# Picton Town Centre - Administration Building

Peer Review  
Planning Proposal

Prepared by: GTA Consultants (NSW) Pty Ltd for Keylan Consulting Pty Ltd  
on 1/12/2020  
Reference: N202510  
Issue #: A

Figure 2.3: Access Location – SLR Report

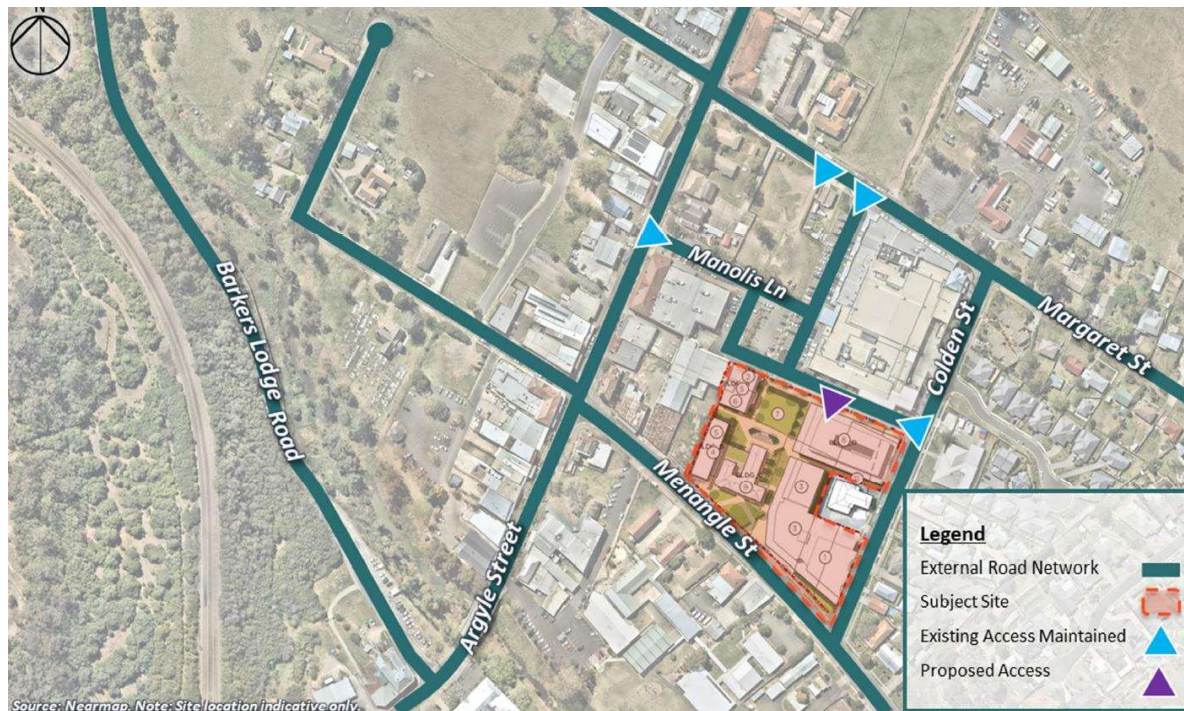
- The SLR Report indicates a single access on Manolis Lane as shown in the extract in Figure 2.3.
- The Elton Report indicates one access on Manolis Lane and one access on Colden Street as shown in the extract in Figure 2.4. The Manolis Lane access is also located further east than the location shown in the SLR Report.

The SLR report proposes a single access from Manolis Lane. As no concept sketches for the administration building indicate this arrangement, it is assumed that this is the incorrect layout, though the following is noteworthy:

- The access location appears to be situated directly opposite the entrance to the basement car park for Picton Mall. It is desirable to offset these driveways to minimise conflicts arising from through movements between these sites.

- Clarification may be required as to whether the AIMSUN software model will need to be updated, noting potentially different movements at the intersection of Manolis Lane and Colden Street.

Figure 2.4: Access Locations – Elton Report

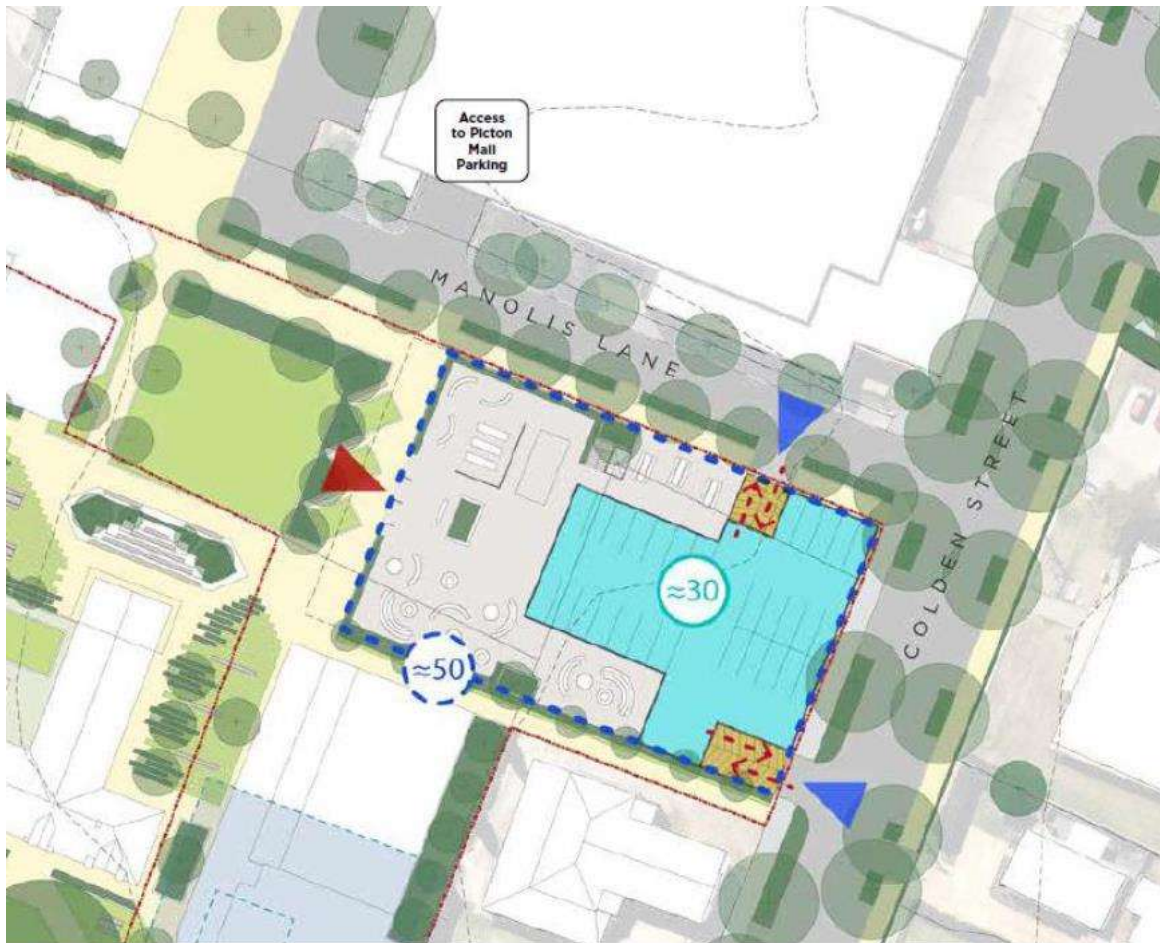
The arrangements for two accesses on Manolis Lane and Colden Street as indicated in the Elton Report are considered to be the intended configuration, given that this is evident in the concept design sketches as shown in the extract from the Urban Design Report in Figure 3.2.

- There is a discrepancy in the access arrangements proposed between the SLR Report and the Planning Proposal report prepared by Elton Consulting. It is believed that the Planning Proposal report shows the intended configuration with accesses on Manolis Lane and Colden Street. These locations are supported.

Figure 3.2: Concept Design

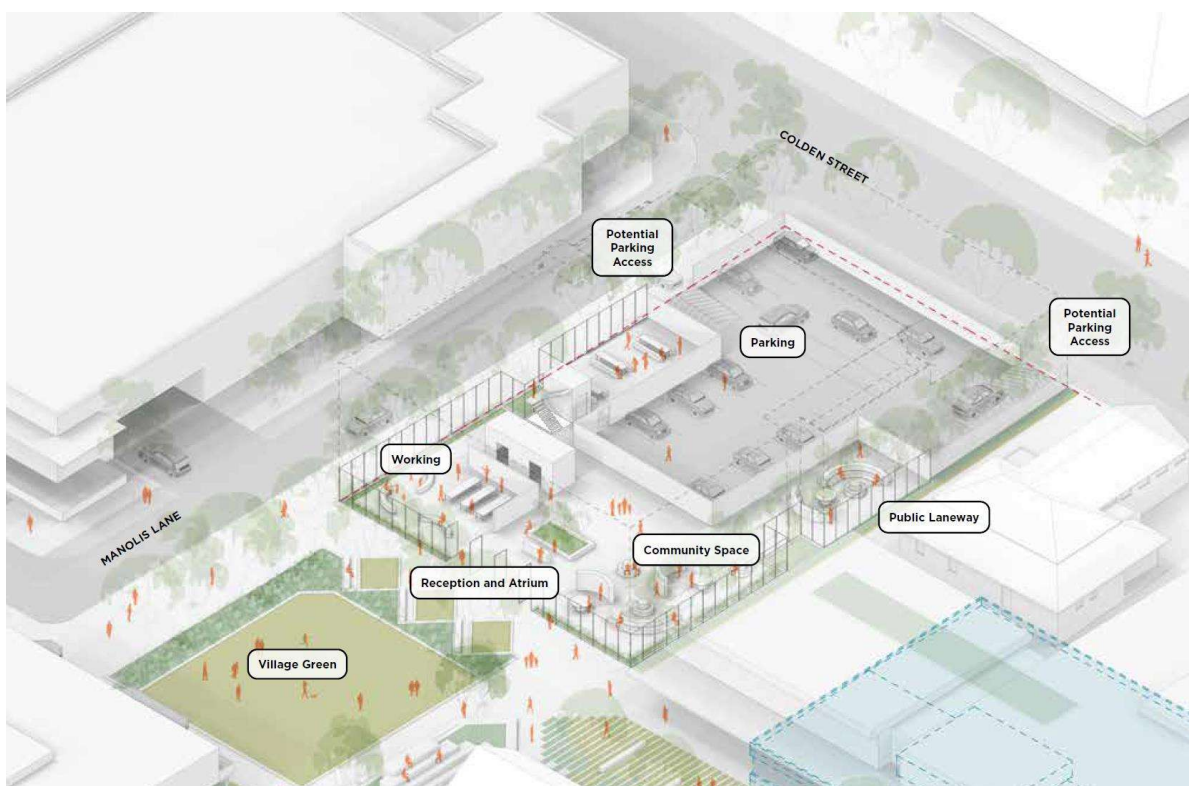
The Urban Design Report also clarifies that these are potential access points, with a final design to incorporate either one or both accesses. The location of these accesses is supportable (no longer opposite major accesses such as Picton Mall) and demonstrates that the basement car park for the new administration building can directly access the external road network without relying on further works associated with the CCCP.

Figure 4.1: Network Comparison

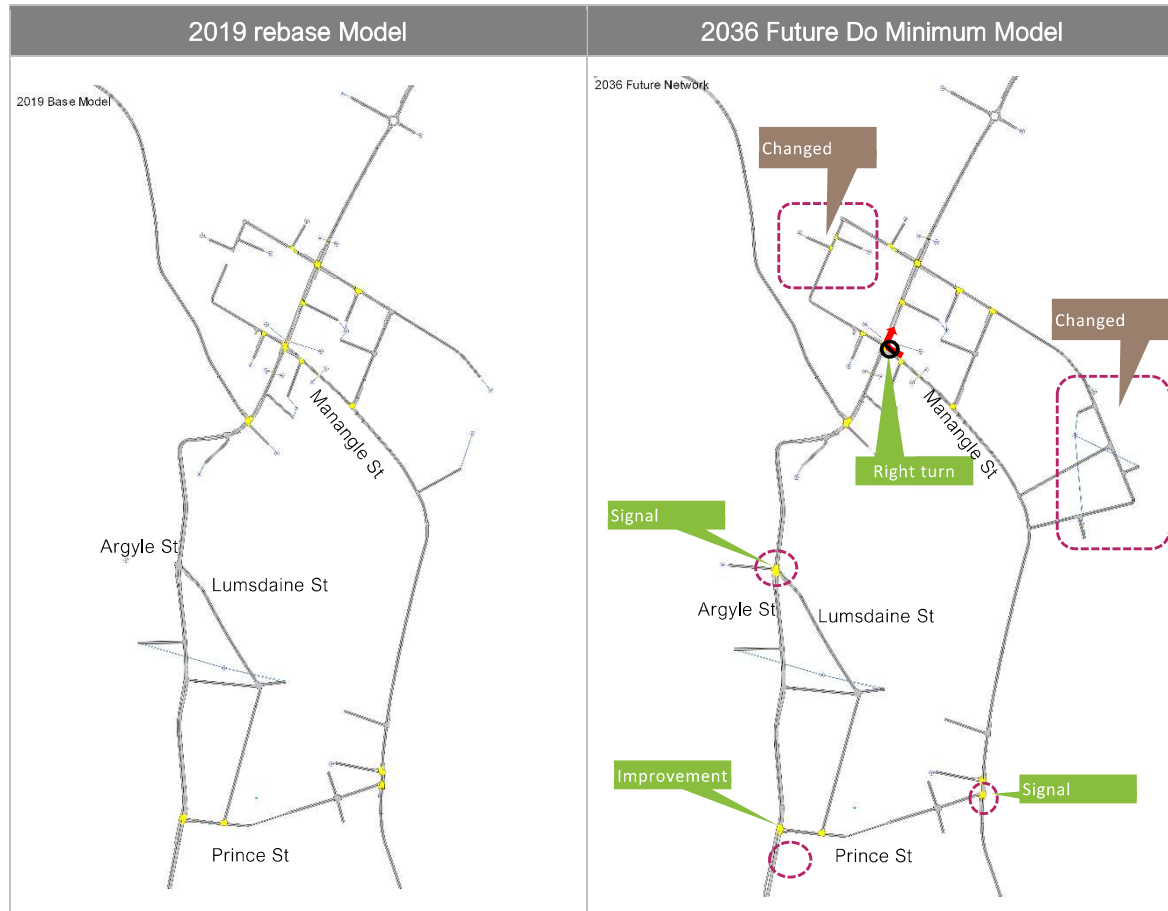
5	Model Comment 2 – Future Model	<ul style="list-style-type: none"><li>The Base and future network layouts are shown in Figure 4.1. Four infrastructure changes have been made based on the 2026 Transport Plan as mentioned in Section 8.3 of the report. However, two areas have changed from the rebased model, as highlighted. Clarification of all network changes for future scenarios is required.</li><li>It is noted that the background traffic growth rate is 1.4% per annum for the AM peak and 1% per annum for the PM peak period. Further information and clarification is required to enable a review of the methodology used for the background demand development for future year scenarios to be undertaken.</li><li>Extra development trips in the model are estimated as 286 veh for the AM peak (3 hours) and 380 veh for the PM peak period (2 hours). Further information and clarification is required to enable a review of the development demand to be undertaken.</li><li>The signal coding at the intersection between Argyle Street and Margaret Street has changed as shown in Figure 4.2. Justification of the changes made to the cycle time and signal phasing is required, since it appears unlikely that the intersection will be coordinated with any of the new upgraded intersections.</li></ul>
